Heritage, Design & Access Statement addendum regarding gates Grove End House

This document describes the historical research and design development work that has been carried out in response to a request from the Heritage and Conservation Officer (HCO). The HCO asked the applicant (email dated 19.07.17) to rework the design of the new gates and the windows / glazed doors between the master bedroom and the belvedere terrace.

Figure 5: Revised design for gates based on photographic records and measured historical details

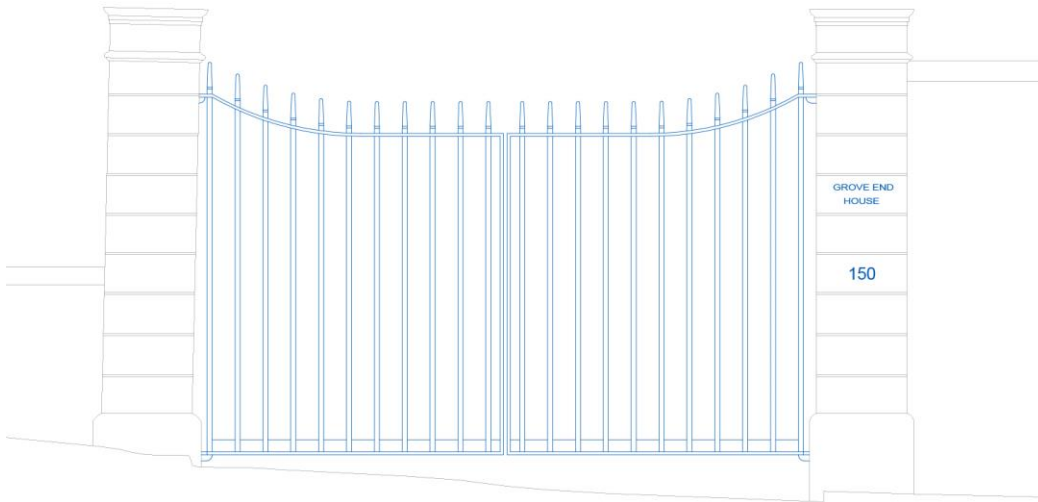
The previous design for the gates was based on an analysis of architectural metalwork in the local area and was described in the Heritage Design & Access Statement. There is a late C19th / early C20th photograph showing gates on Grove End House (see figures 1 & 2).

These gates were previously thought to be a Victorian addition and were consequently not taken as the starting point for the design of the new gates. Cross-referencing to source books on Georgian architecture, the applicant is now convinced that the gates in the photographs are the originals. By counting the uprights, aligning with the grooves in the gate piers and following historical guidance on dimensions, a faithful reproduction of the original is possible. The main sources for the details have been measurements from existing railings in Grove Terrace (figures 3 & 4) and a document titled 'Railings in Westminster – A Guide to their Design, Repair and Maintenance' published by the City of Westminster.

Figure 6: Revised design for master bedroom windows Option 2

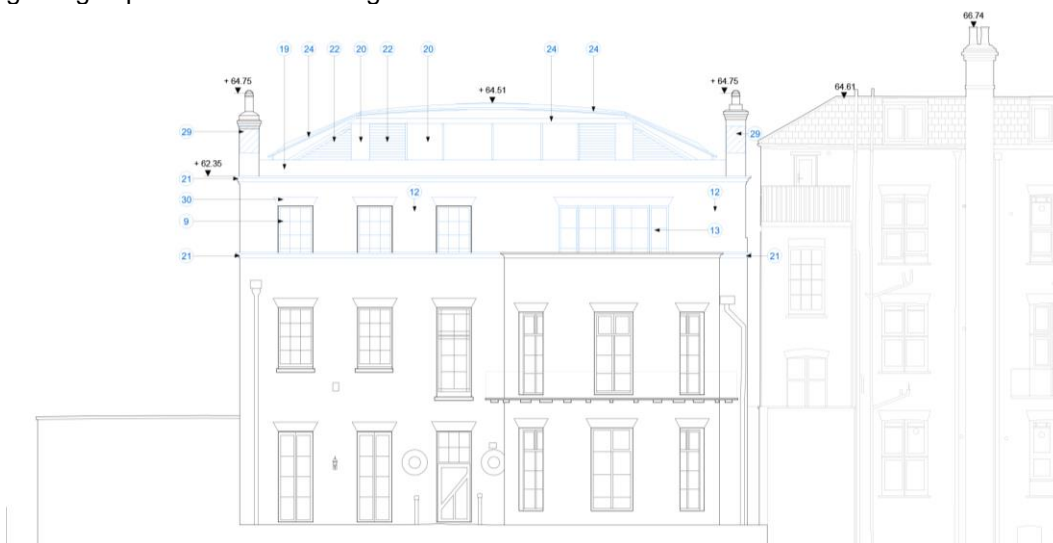
The HCO requested the applicant to rework the design of the master bedroom windows / glazed doors so that it would have a more traditional appearance due to this element being visible from certain viewpoints. The applicant explored a number of options including the following:

1. Applying the same arrangement of glazing bars as the other second floor windows (which in turn had been based on the existing 'six-over-six' windows below)
2. Applying the same arrangement of glazing bars as the windows on the belvedere and the ground floor French windows which feature slightly larger panes than the 'six-over-six' windows

Option 1 resulted in a 'busy' appearance of glazing bars that was felt to be less consistent than the Option 2 in terms of how the new glazed doors related to the other door-sized elements of existing glazing. Option 2 is shown in figure 6 below.
